**Planning**  
ADDITIONAL INFORMATION

Project  
Stoney Hill Road, Rathcoole, Co. Dublin

Drawing  
PROPOSED CONTEXTUAL 5 - EAST PART 2  
PROPOSED CONTEXTUAL 5 - SITE SECTION

PROPOSED CONTEXTUAL 5 - SITE SECTION NORTH SOUTH (PART 2 OF 2)  
SCALE 1:200  
WALL ADJUSTED AS PER PLANNING RT

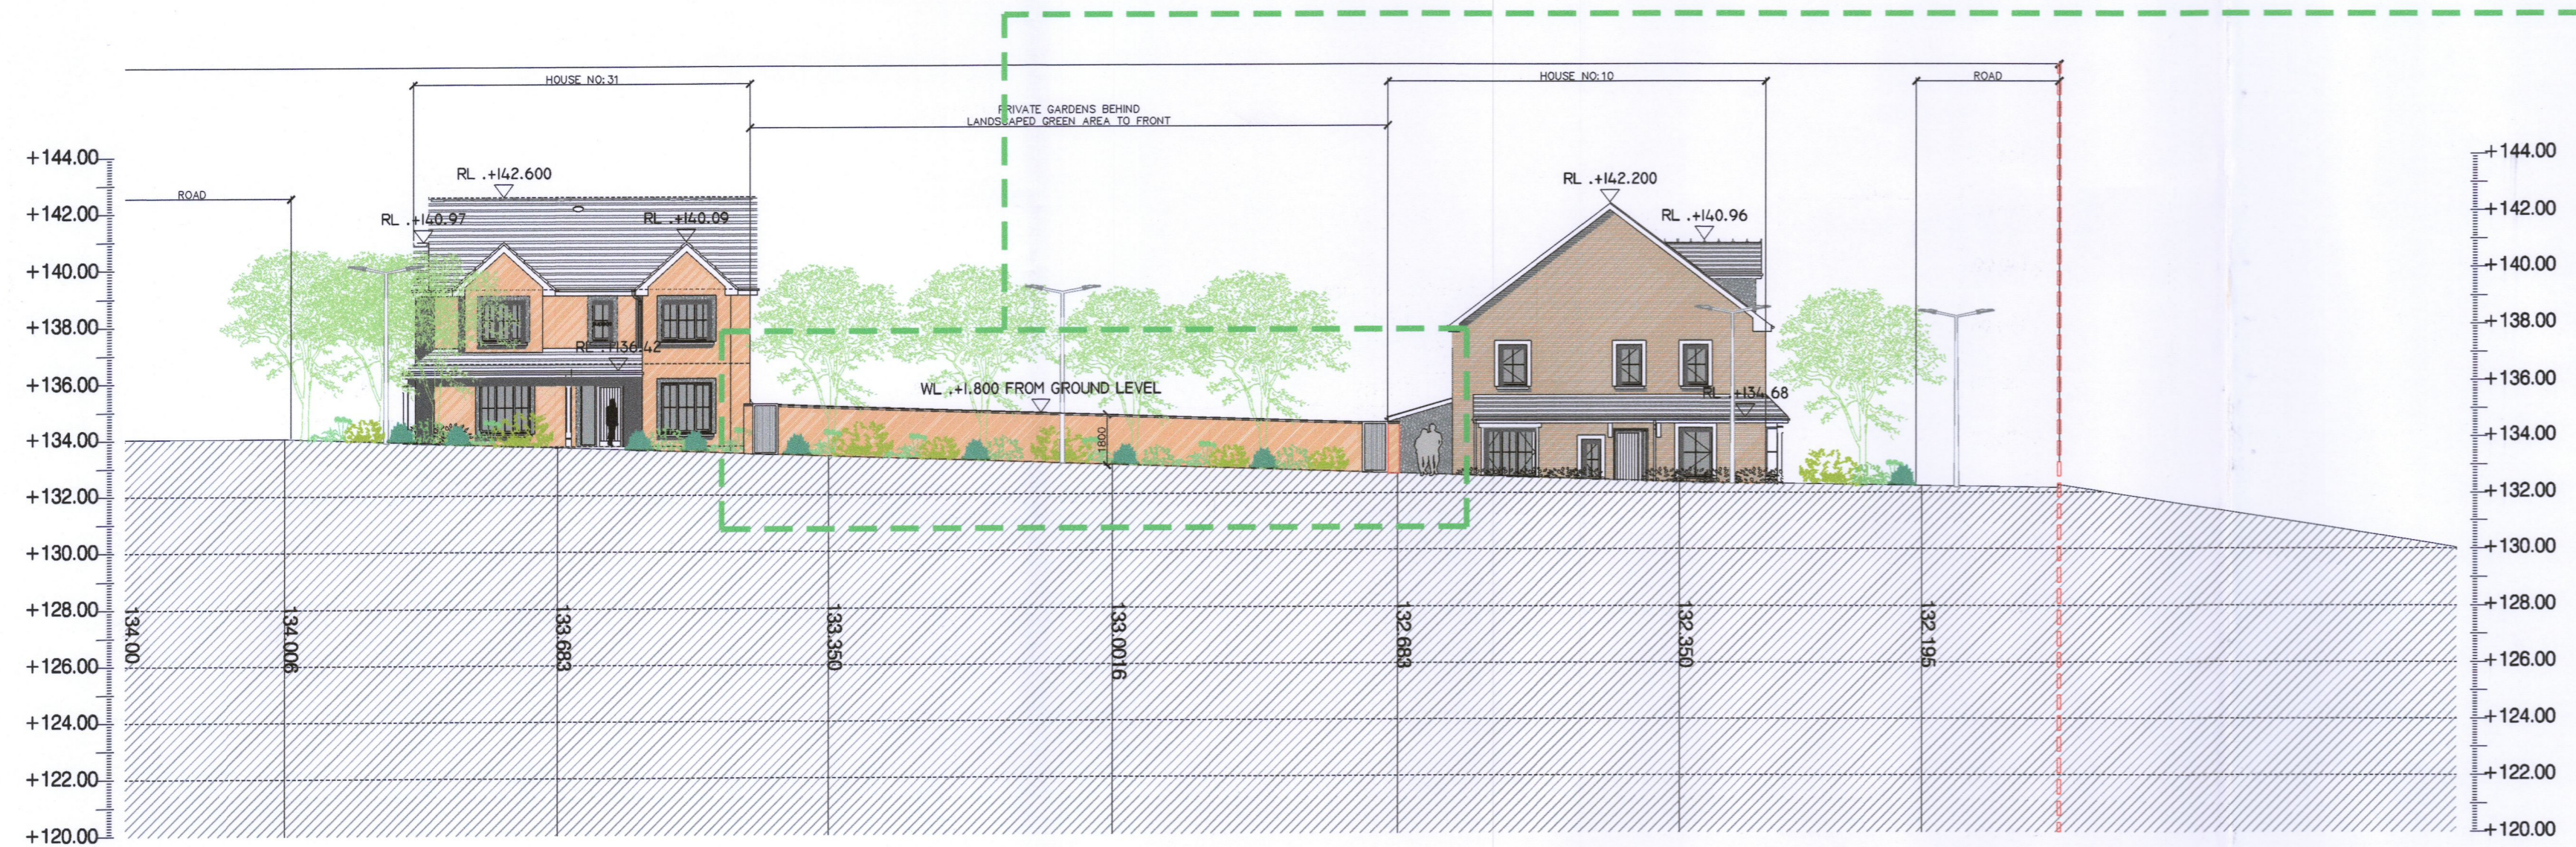
**2. LAYOUT**  
(b) THE SUBMITTED SITE SECTION SHOWS THAT THE GARDEN WALLS WOULD NOT BE TALL ENOUGH TO ENSURE PRIVACY AT SOME POINTS ALONG THE CENTRAL STREET.  
**RESPONSE: ALL WALLS HEIGHTS ADJUSTED TO 1.8M HEIGHT TO ENSURE PRIVACY TO PRIVATE GARDENS FROM CENTRAL STREET.**
